Department of Mines
South Australia

REPORT ON SUITABILITY OF PROPOSED SUB-DIVISION

PT. SECTION 874, HD. ADELAIDE

Town Planner's Office

Approved	Passed	Drn.	DRAINAGE INSPECTION PT. SEC. 874 Hd. ADELAIDE TOWN PLANNER	D.M.	Scale 40 ch. to 1 in
		Tcd.		Req.	52352
		Ckd.			H & G
Director		Exd.			Date 13-1-60

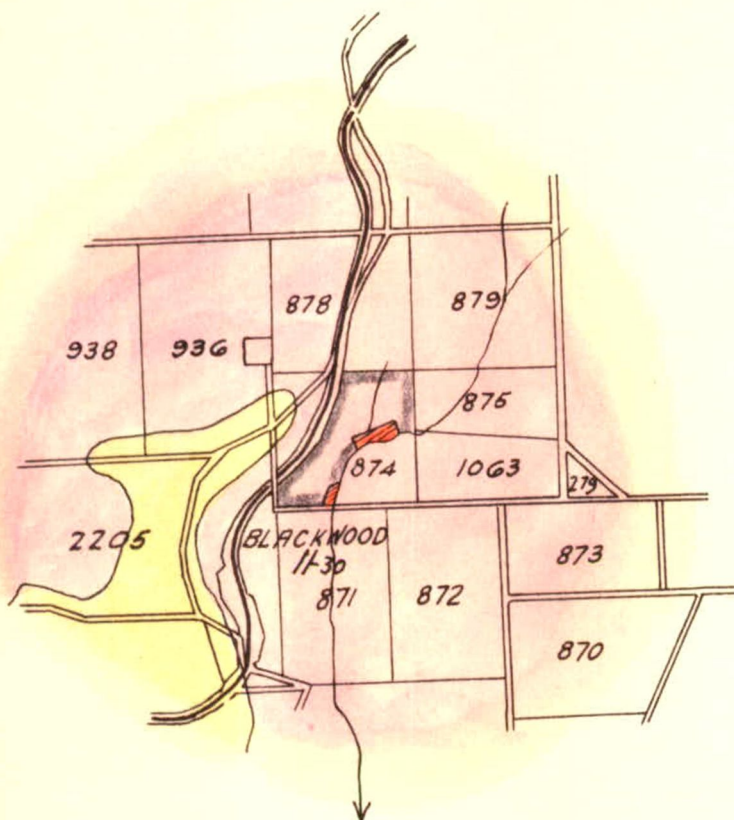
Under these conditions it is considered that the proposed allotments should be somewhat larger, preferably at least $\frac{1}{2}$ acre in area. This seems particularly desirable for the area occupied by allotments 59-63 and 70-113. This area has the steepest slope of the proposed subdivision and although surface run-off is rapid, there is a considerable risk of soil creep. With larger allotments it should be possible to dispose of septic tank effluent through shallow pits as there is a lesser possibility of the soil becoming saturated.

a wet winter, particularly if run-off is increased in the upper part of the area. It is therefore suggested that allotments 114-117 and 118-124 should not be included in the proposed sub-division.

Provided adequate surface drains are constructed the northern part of the area appears to be suitable for the proposed sub-division. However, it is considered that larger allotments would be preferable. It is suggested that a drain should be allowed for between the boundaries of blocks 1-7 and 10-18. Such a drain would remove excess water rapidly from this area.

The area generally appears to be suitable for sub-division, provided it is adequately drained. It is considered that the allotments should have a larger area, particularly where the slopes are steep. It is therefore suggested that the area of allotments 59-63 and 78-113 should be subdivided into larger allotments, preferably of $\frac{1}{4}$ acre area.

An area along the creek including allotments 114-117 and 118-124 is considered to be unsuitable for subdivision because of the possibility of waterlogging.
